Subject: EPA Comments on NRG - Huntley Generating Station, Tonawanda, NY  
Round 10 Draft Assessment Report

RE: Comment Request on Coal Ash Site Assessment Round 10 Draft Report –  
NRG Huntley Power, LLC's Huntley Electric Generating Station

Appendix A  
NRG Comments on  
Draft Report of Dam Safety Assessment of Coal  
Combustion Surface Impoundments  
NRG Energy  
Huntley Generating Station  
Tonawanda, NY

Re: GZA Letter Response to AMEC  
Dam Safety Assessment Report of  
Coal Combustion Surface Impoundments  
NRG Energy Huntley Generating Station  
Tonawanda, NY

# NRG Embankment Evaluation, Static Condition @ South Ash Settling Basin

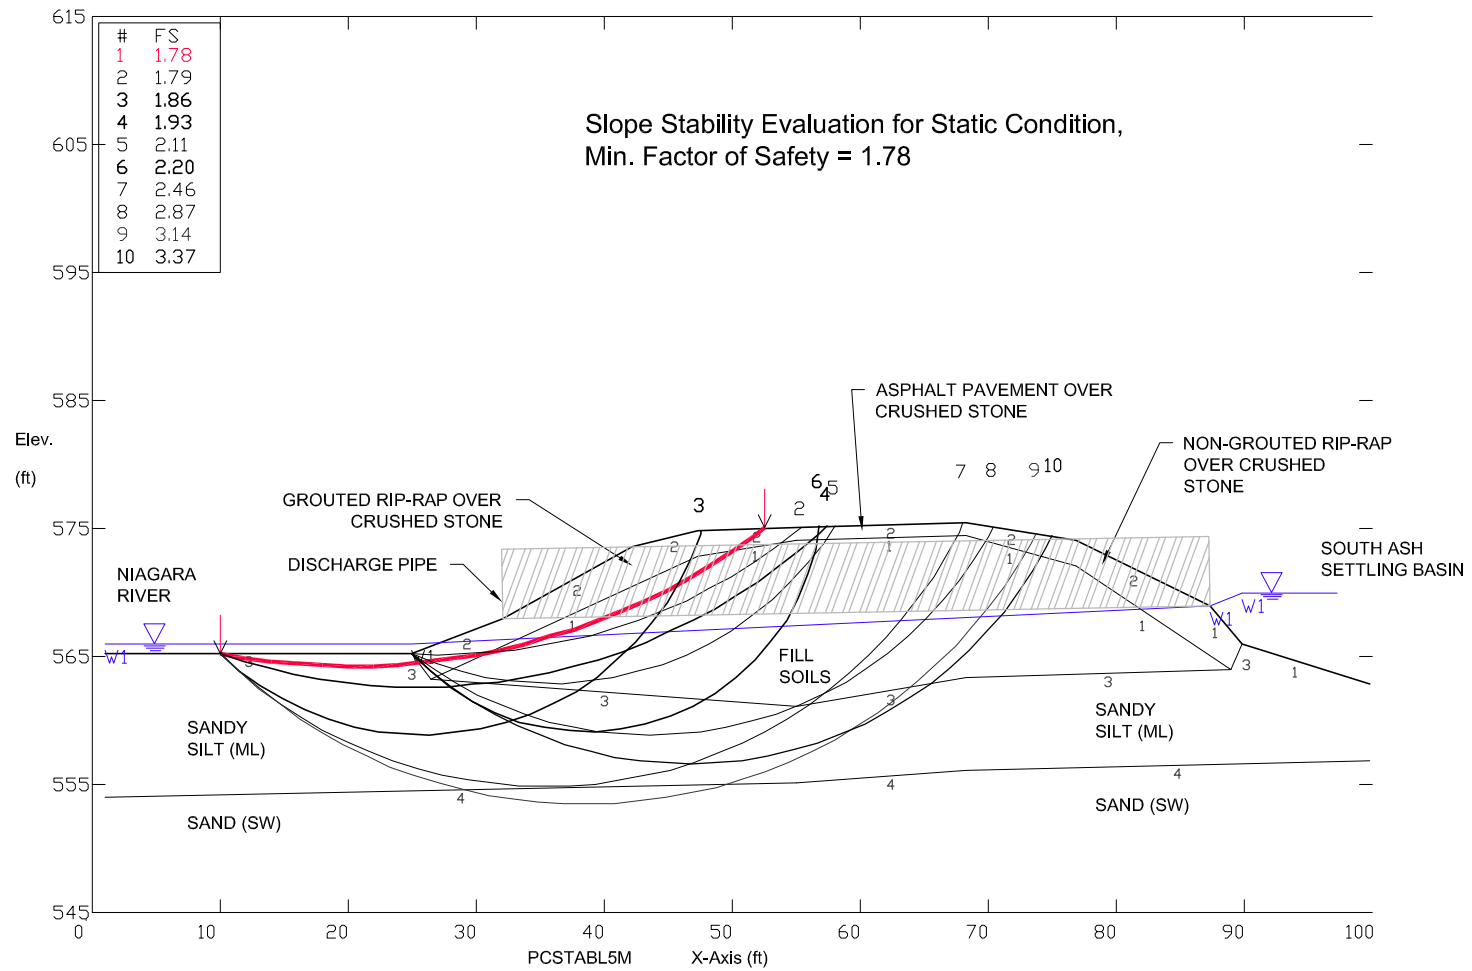
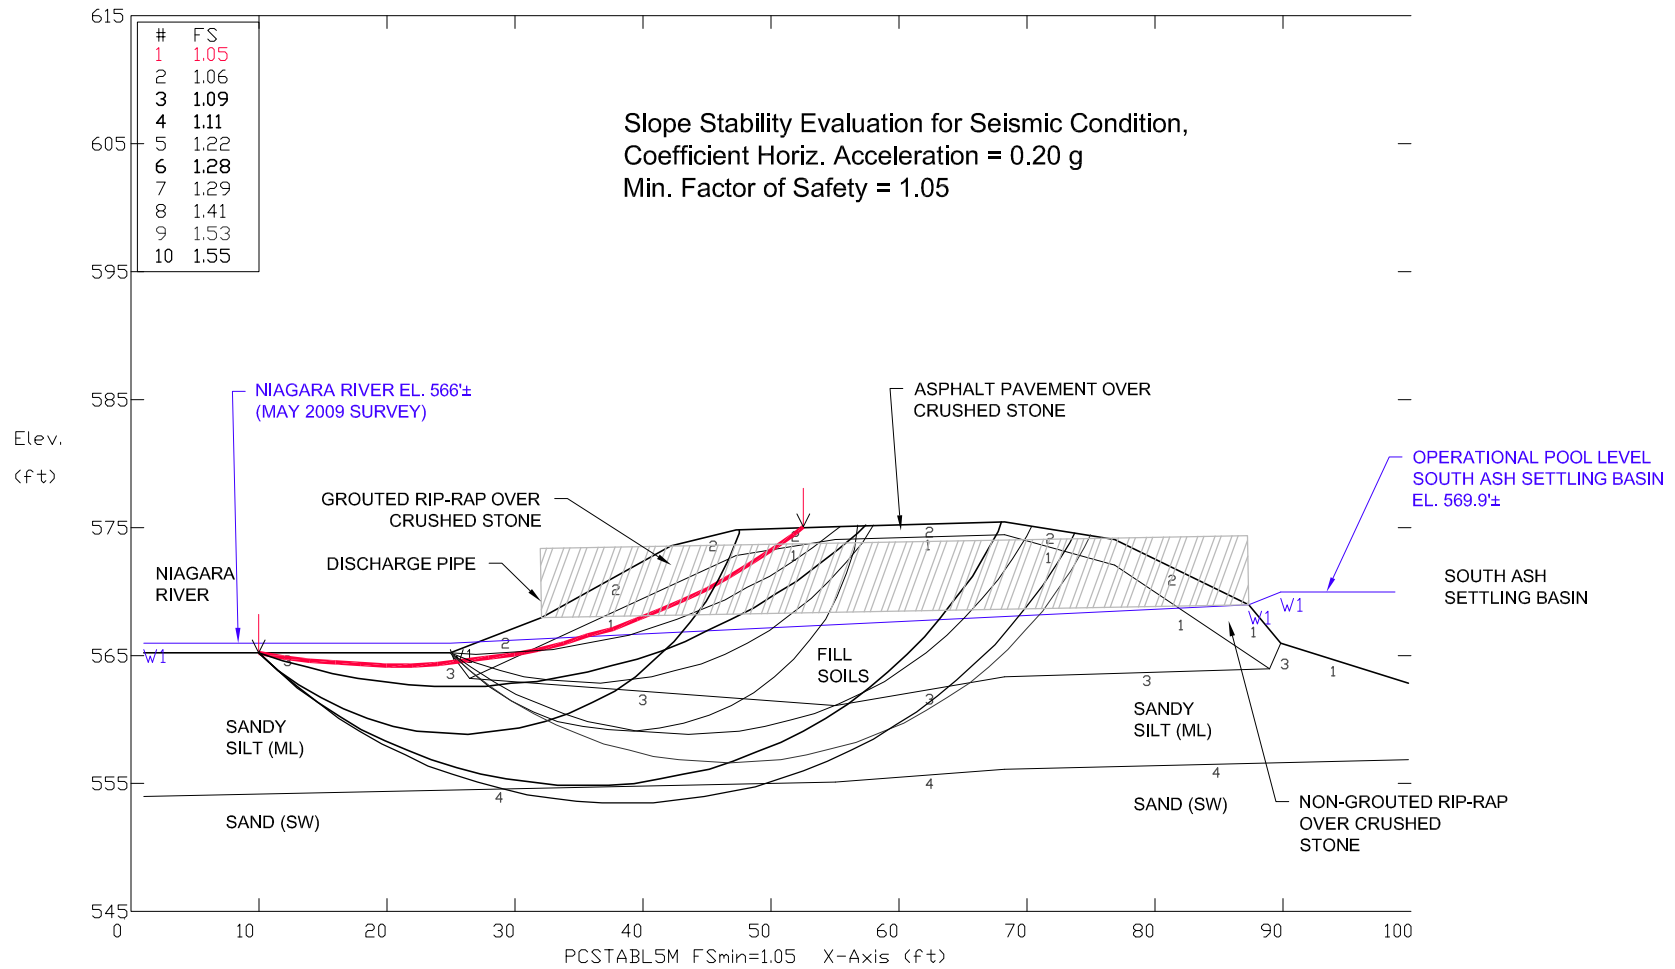
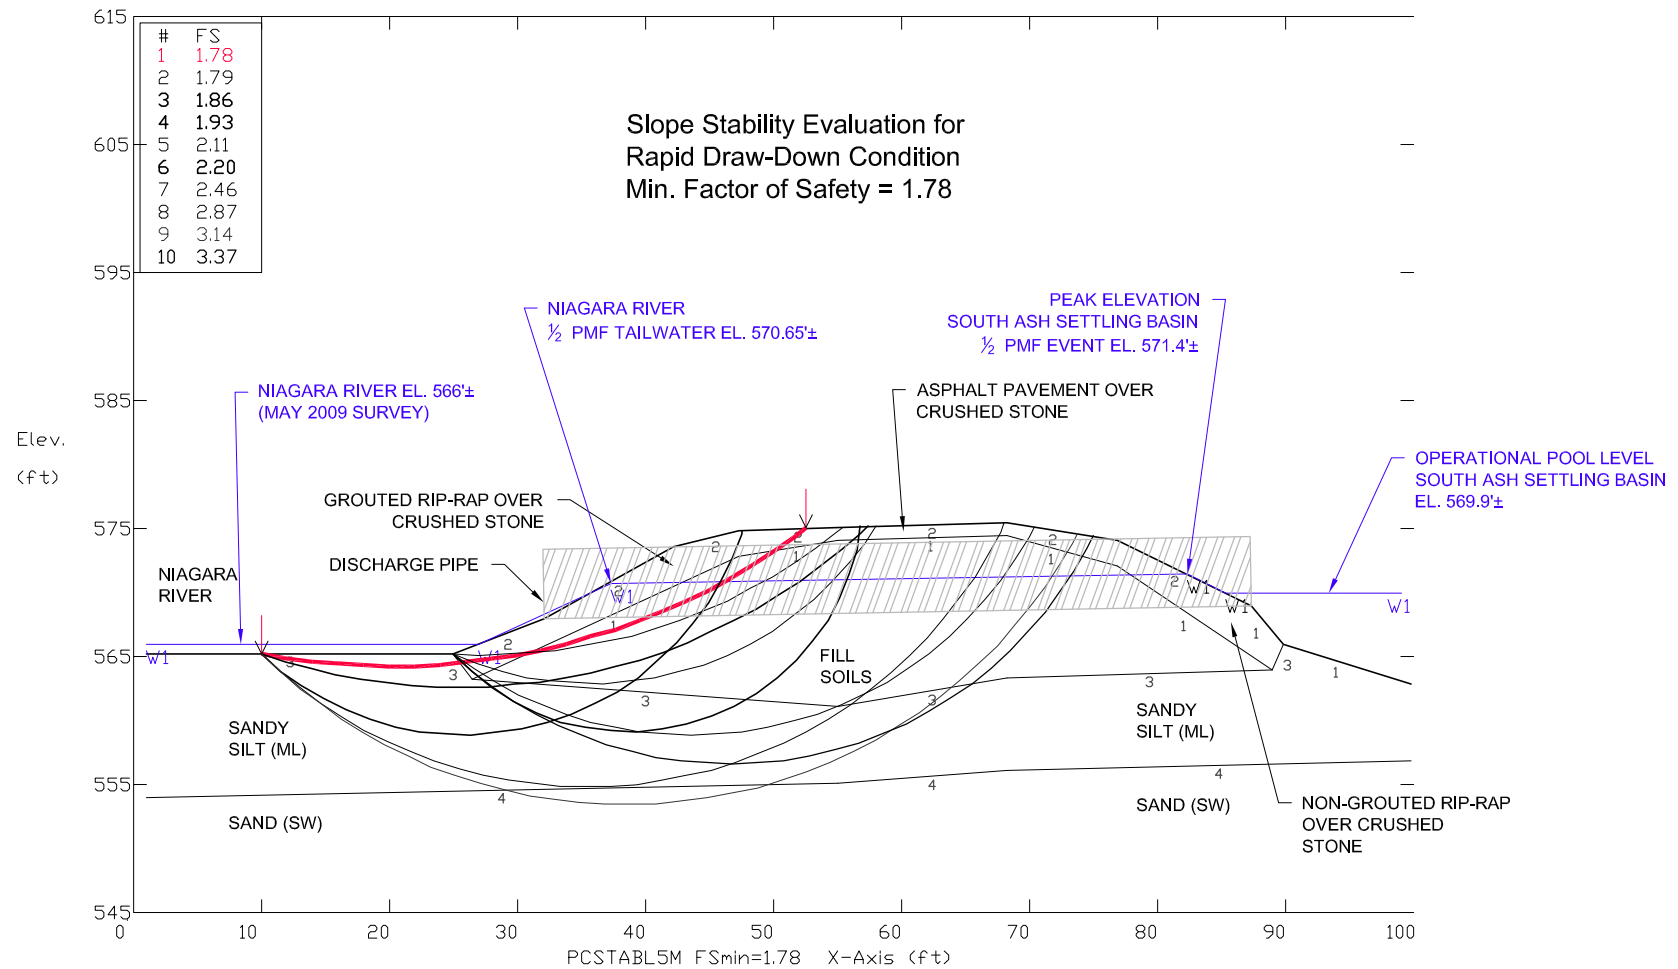
- 3.3.1, General In regards to the Seismic Analysis – South Ash Pond, NRG has provided in Appendix C a Stability Analysis from GZA to address this deficiency.

- 4.2.2, General In regards to the South Ash Settling Pond, NRG has provided in Appendix C a Stability Analysis from GZA to address this deficiency.
- 4.3.2, General Vegetation covering embankments have been cut for inspection. See Attached Inspection Report from GZA in Appendix B.

1. The friction angle used for the fill (30 degrees) may be high due to the presence of soft zones and debris noted in the boring.
2. Although the GZA report provided comments on liquefaction due to seismic activity, a seismic stability is not presented. AMEC recommends that the analysis be revised to include a seismic analysis. The analysis should be reviewed after completion of the recommended hydraulic study to evaluate elevated phreatic conditions and the need for a rapid drawdown analysis based on flood and receding waters of the Niagara River.

Analyses were done for static and seismic conditions assigning a conservative internal friction angle of 30 degrees for the general berm fill and a friction angle of 35 degrees for the surficial layer where concrete matting exists along the embankment slopes. The static analyses were done with a phreatic surface representing the ½-PMF rain event, and the seismic analyses were done with a phreatic surface representing normal pool elevations. Rapid drawdown analyses were not done since we consider the change in water level negligible for the given conditions.
